Access Compliance Report

Public Rights-of-Way

(Curb Ramps)

Intersection ID: 11546	Main Street: HEYWOOD_AV	Cross Street: KEMPTON_PL	Location: W
ADA ID: 7F64E6E8DA3F	Ramp Type: BlendTrans1	Initial Pass/Fail: Fail	Overall Compliance: No
Severity Score: 1.25			
Codes/Mitigation Info/Possible Solution		Field Measurements/Component Compliance

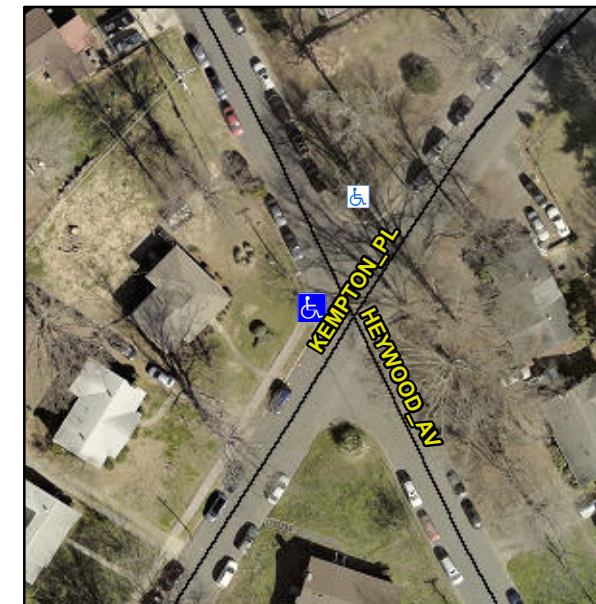
Not Found, R304.5.3

Compliance	Description	Data	Compliance	Description	Data
N/A	Ramp Length (in)	30.0	Yes	BlendTrans Slope (%)	4.2
Yes	Ramp Width (in)	48.0	No	BlendTrans XSlope (%)	3.5
N/A	Flare Type LT	N/A	N/A	Flare Type RT	N/A
N/A	Flare Slope LT (%)	N/A	N/A	Flare Slope RT (%)	N/A
N/A	Flare Traversable LT?	N/A	N/A	Flare Traversable RT?	N/A
N/A	Landing Length (in)	N/A	N/A	DWS Provided?	N/A
N/A	Landing Width (in)	N/A	N/A	DWS Contrast?	N/A
N/A	Landing Slope (%)	N/A	N/A	DWS Length (in)	N/A
N/A	Landing X Slope (%)	N/A	N/A	DWS Full Width?	N/A
N/A	Landing Curb? (Y/N)	N/A	N/A	DWS Offset (in)	N/A
N/A	Shared Landing?	N/A			
N/A	Gutter Ponding?	N/A	N/A	Gutter Slope (%)	N/A
N/A	Gutter Lip Ht (in)	N/A	N/A	Gutter X Slope (%)	N/A
N/A	Painted X Walk1?	No	N/A	Painted X Walk2?	N/A
	X Walk 1 Direction	To NE		X Walk 2 Direction	N/A
	X Walk 1 Width (in)	N/A		X Walk 2 Width (in)	N/A
	X Walk 1 Slope (%)	1.4		X Walk 2 Slope (%)	N/A
	X Walk 1 X Slope (%)	2.3		X Walk 2 X Slope (%)	N/A

N/A	Ramp inside XWalk1?	N/A	N/A	Ramp inside XWalk2?	N/A
	Road Slope (%)	2.3		Clear Space?	N/A
	Road X Slope (%)	1.4	N/A	Clear Space to XWalk (in)	N/A
N/A	Any Obstructions?	N/A	N/A	Storm Grate/Utility Hazard?	N/A
	Obstruction Type			Storm Grate/Utility Type	
		N/A			N/A
			Yes	Surface Condition? (G/P)	Good
			No	Curb Slope (%)	8.0

Remove & Replace Curb Ramp With Two New Directional Ramps or Equivalent.
